EQUIPMENT/FURNISHINGS - OPTION FOR LARGER HEADSET HOOK

To provide an option to install a larger headset hook.

SB525-25-34  
Page 1 of 6

Figure 1. Headset Hook Installation (Sheet 1)

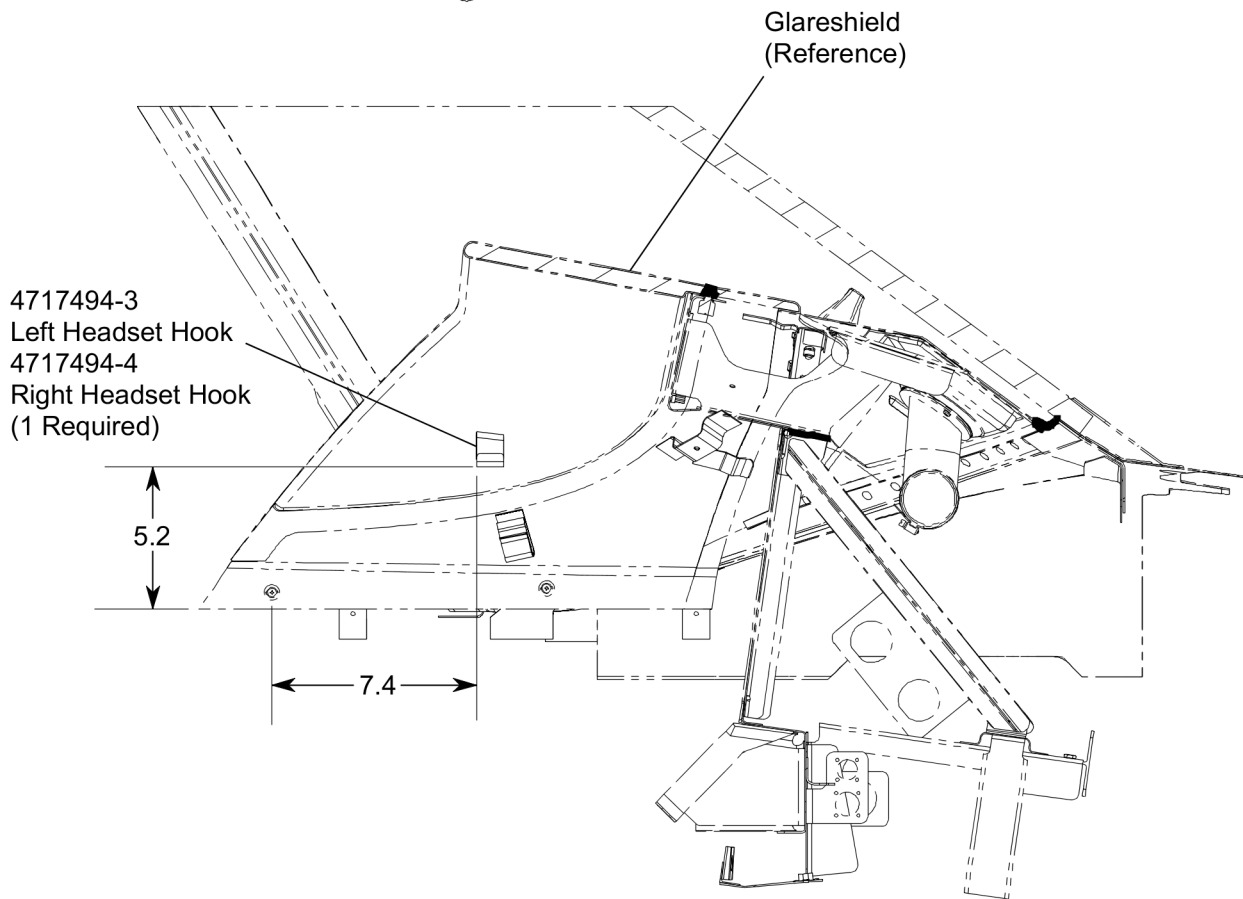
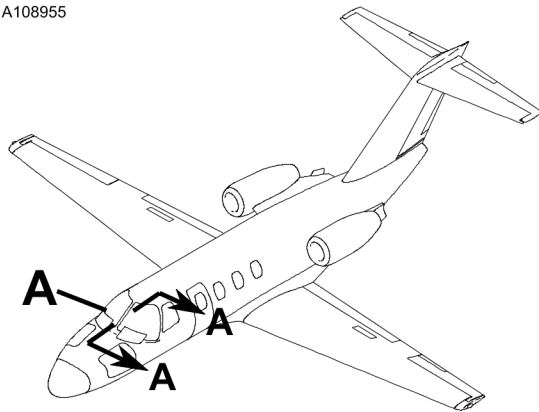
2. (Refer to Figure 1, Detail A and View A-A.) Install the 4717494-3 Left Headset Hook.
  - A. Lightly abrade the mating surface of the glareshield and the headset hook.

- E. Install the 4717494-3 Left Headset Hook on the glareshield.
    - (1) Make sure the hook portion of the headset hook is level.
  - F. Wipe away excess adhesive with isopropyl alcohol.

3. (Refer to Figure 1, Detail A and View A-A.) Do Step 2.A. thru 2.F. to install the 4717494-4 Right Headset Hook.
4. Remove the maintenance warning tags and connect the airplane battery.
